## Groundwater Transfer Review Summary Form

Transfer/PA # T- 13044

Application: T-13044

Applicant Name: Mayfield Farms, LLC

# T-13044 Mayfield Farm, LLC

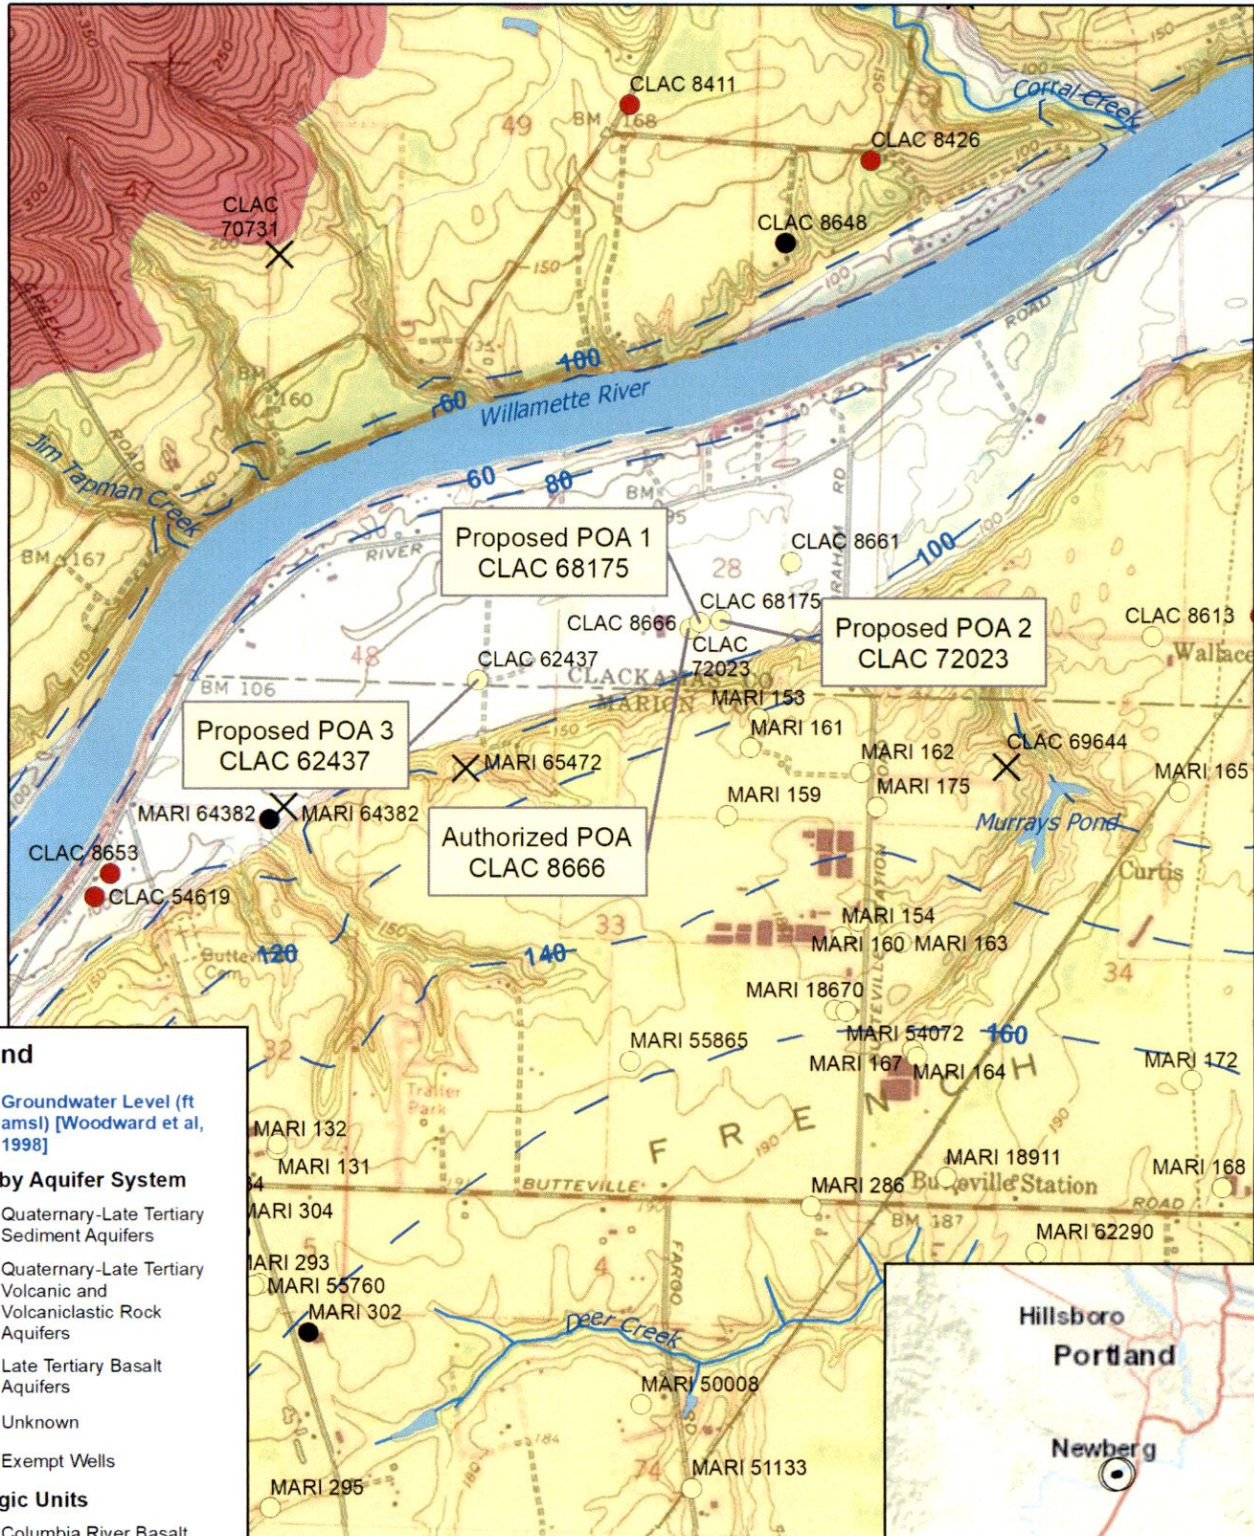
2. Will the proposed POA develop the same aquifer (source) as the existing authorized POA?  
 Yes     No    Comments: The authorized POA (CLAC 8666) and the proposed POA 1-3 (CLAC 68175, 72023, and 62437) are all completed in the younger alluvium of the Willamette River floodplain. The authorized POA (CLAC 8666) produces water from gravel between ~80 and ~105 ft below land surface (bls), while the proposed POA 1-3 (CLAC 68175, 72023, and 62437) produce water from saturated sands and gravels between ~30 and ~110 ft bls. Static water level in the authorized POA (CLAC 8666) was reported at 1 ft bls in June 1968, indicating confined conditions. Proposed POA 1-3 (CLAC 68175, 72023, and 62437) likewise appear confined, with reported static water levels around 3 ft bls at their times of completion. All of the saturated alluvial sediments in this area are presumed to be strongly influenced by the seasonal discharge of the Willamette River.

Yes  No Comments: The proposed POA 3 (CLAC 62437) is ~1,830 ft (~66 percent) closer to Exempt Well MARI 65472 (Well Completion Date 9/22/2014) than the authorized POA (CLAC 8666). The productive water-bearing zone noted on the well log for MARI 65472 is at a similar elevation to CLAC 62437. The closer proximity of CLAC 62437 will likely result in increased well-to-well interference with MARI 65472. The proposed POA 2 (CLAC 72023) is also ~330 ft (~26 percent) closer to CLAC 8661, which is an authorized POA for **Certificate 38320\*** (Priority Date 6/16/1964). CLAC 72023 and CLAC 8661 appear to produce water from the same confined aquifer. The closer proximity of CLAC 72023 will likely result in increased well-to-well interference with CLAC 8661.

Yes  No Comments: The proposed POA 1-3 (CLAC 68175, 72023, and 62437) are at equivalent distances from the Willamette River, the nearest hydraulically-connected surface water source, as the original authorized POA (CLAC 8666). Therefore, no appreciable increase in interference with nearby surface water sources is anticipated under the proposed transfer.

**Theis Drawdown Analysis – CLAC 72023 to CLAC 8661**

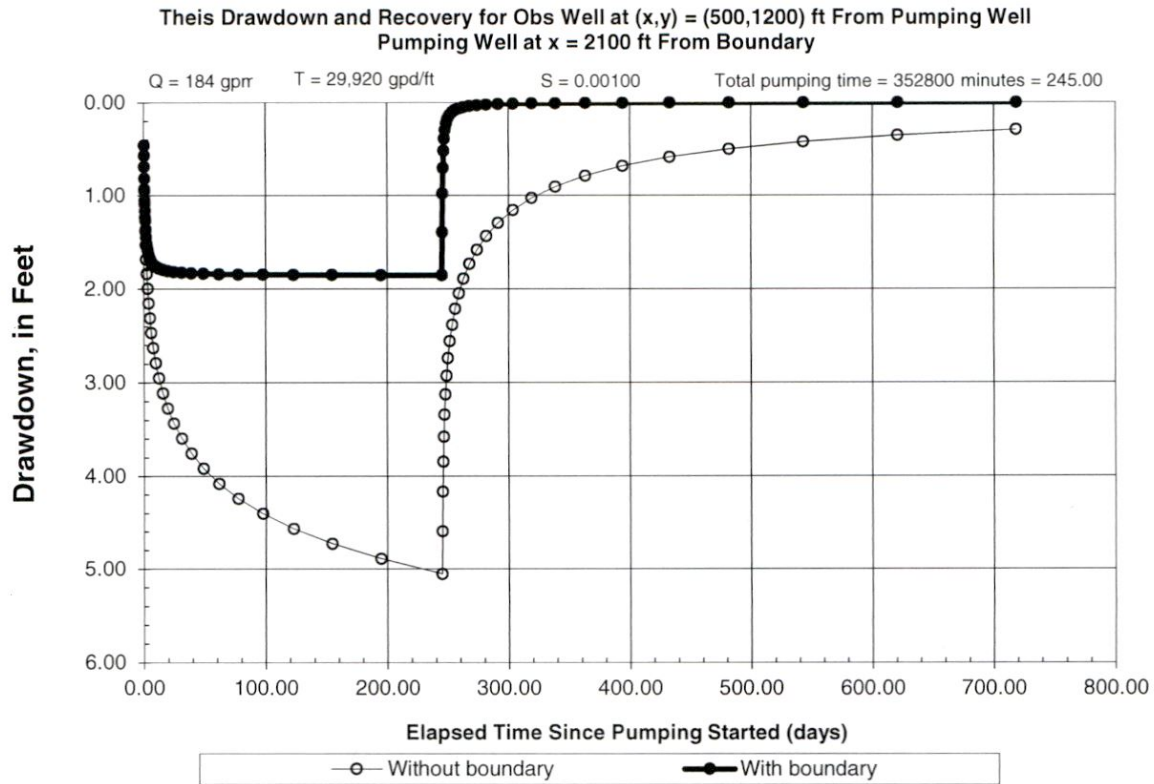
Using the Theis distance-drawdown method (Theis, 1941), the relative increase in potential drawdown at CLAC 8661 due to pumping of the proposed POA 2 (CLAC 72023) – rather than the authorized POA (CLAC 8666) – was estimated based on 245 days of continuous pumping at the maximum requested rate (0.41 cfs / ~184 gpm) (see Theis Drawdown Analyses for CLAC 8666 and CLAC 72023, attached). Results from the Theis analysis indicate a relatively small amount of additional drawdown would result from the use of CLAC 72023 instead of CLAC 8666. This marginal increase in potential drawdown is unlikely to prevent the customary use of groundwater under **Certificate 38320\*** or other nearby senior groundwater rights, particularly given the substantial influence of the nearby Willamette River.
